MeshSat field kit V2, Option A(i) lid pack: sheet A1-1 arrangement B in plan: the lid module, the QMX set and every face part under the lid

MESH SAT-1357, stream a1mech, 29 Sep 2026. Case frame: X east, Y toward the hinge (back) wall, Z up from the base floor, lid closed. mm. Prototype design, AI review: nothing built, bought or fitted; analytical success is not physical verification.

MeshSat field kit V2, Option A(i) lid pack: sheet A1-3 the arrangements that fit, and the owner decision

MeshSat field kit V2, Option A(i) lid pack: sheet A1-4 the hinge harness: route, travel, ties, disconnect; the QMX DC lead re-routed

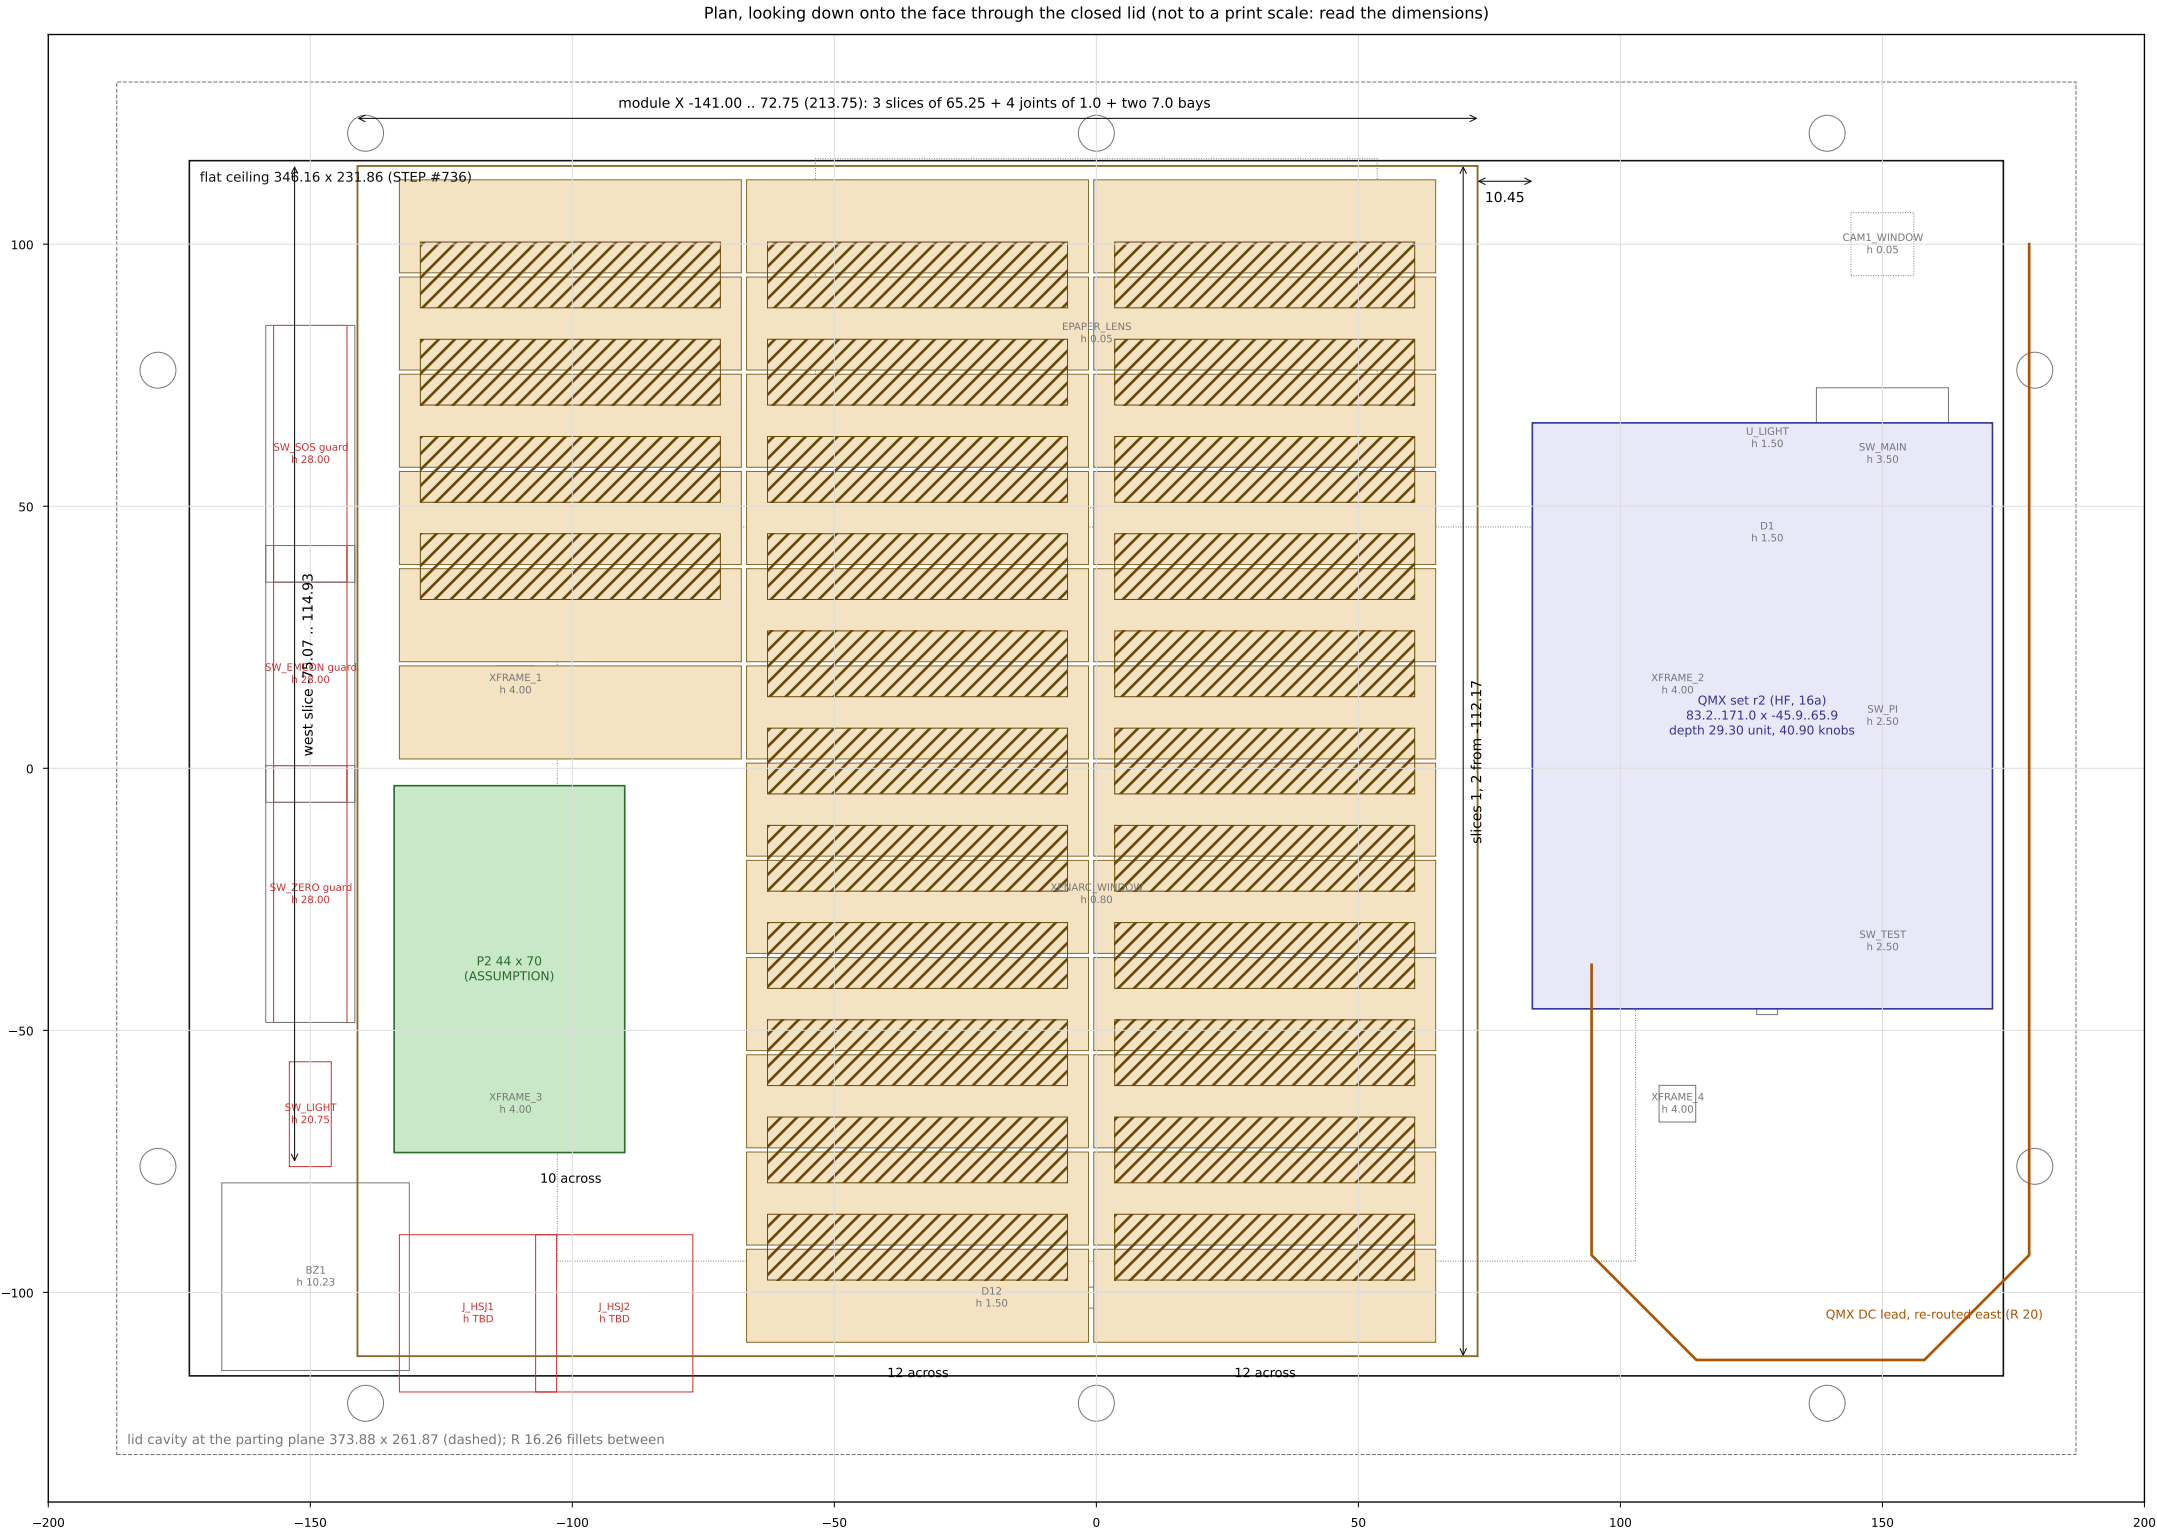
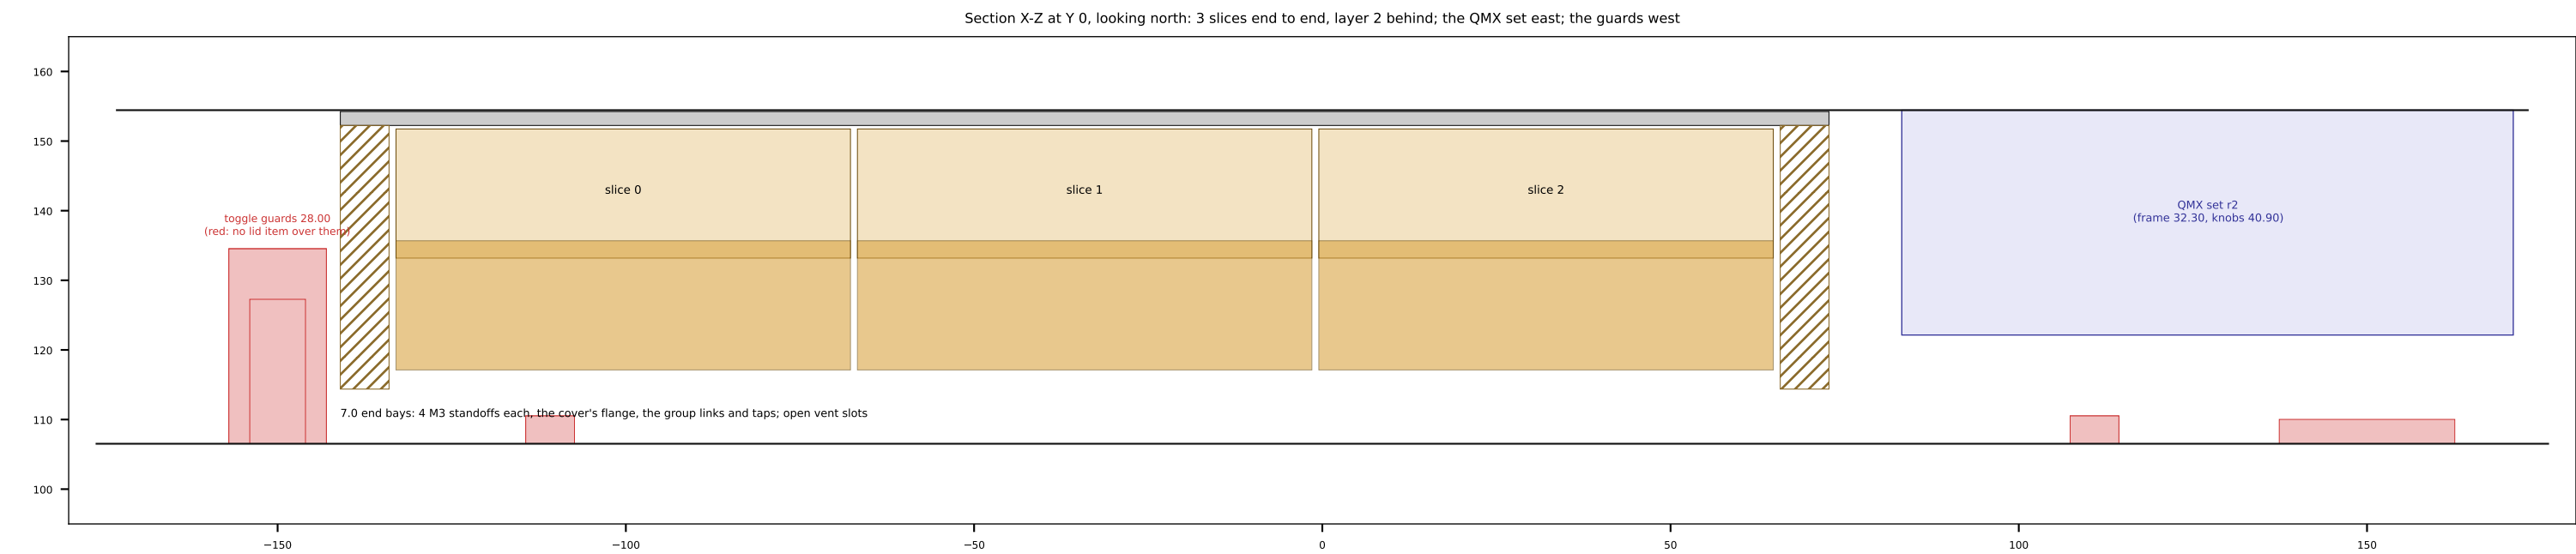
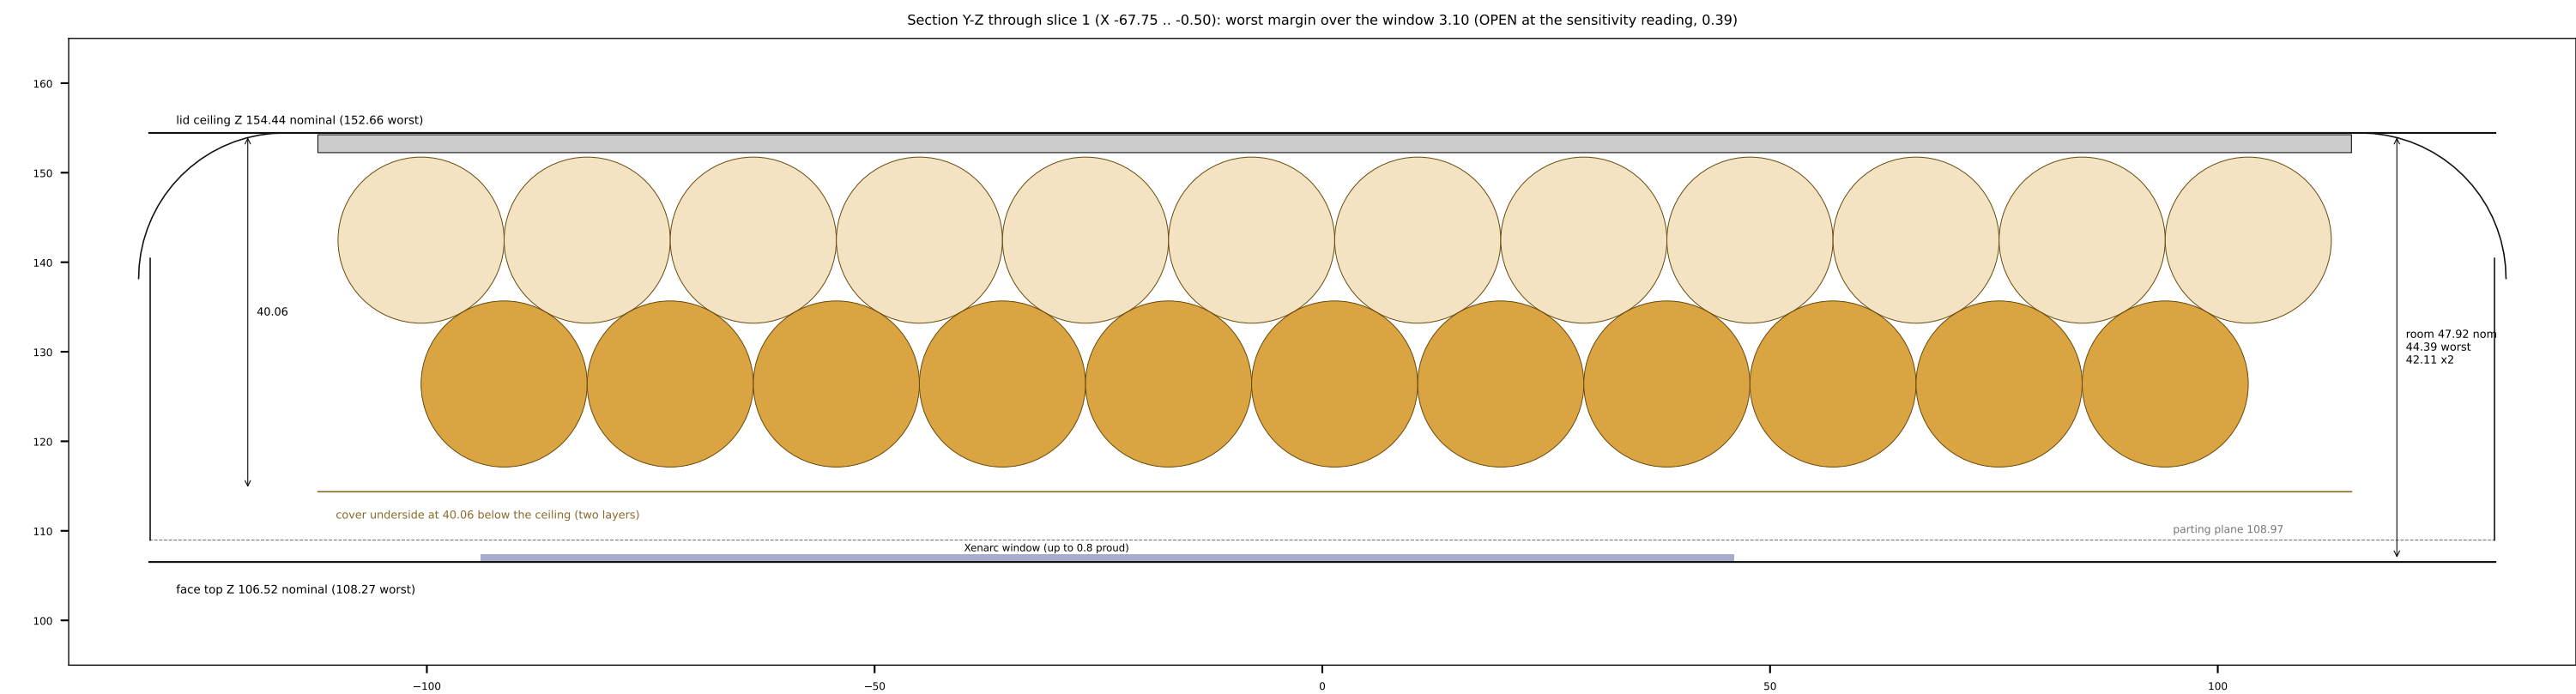
TIGHTEST ROWS (worst, x2; min 1.0)
two layers over the Xenarc window 0.80: 3.10, 0.39 OPEN
two layers over the LED bar 1.50: 2.40, -0.31 OPEN
two layers over the e-paper lens: 3.85, 1.14 MET
one layer over the XFRAME screws: 15.96, 13.25 MET
layer 2 refused over XFRAME_1 and _3 (4.00): -0.10 worst

PLAN module to the QMX tray 10.45; inside the flat ceiling
1.00 in Y (the fillets begin at +-115.93)
west edge 2.0 from the toggle guard caps (X -143.0)
west slice stops north of the headset jacks (TBD)

OPEN AT THE MOCK-UP: T9 (chalk on the module's cover and the
face parts, lid closed), T8 (pull test of a bonded plate on
Peli's polypropylene), T-A1-1 to T-A1-4 of the README.
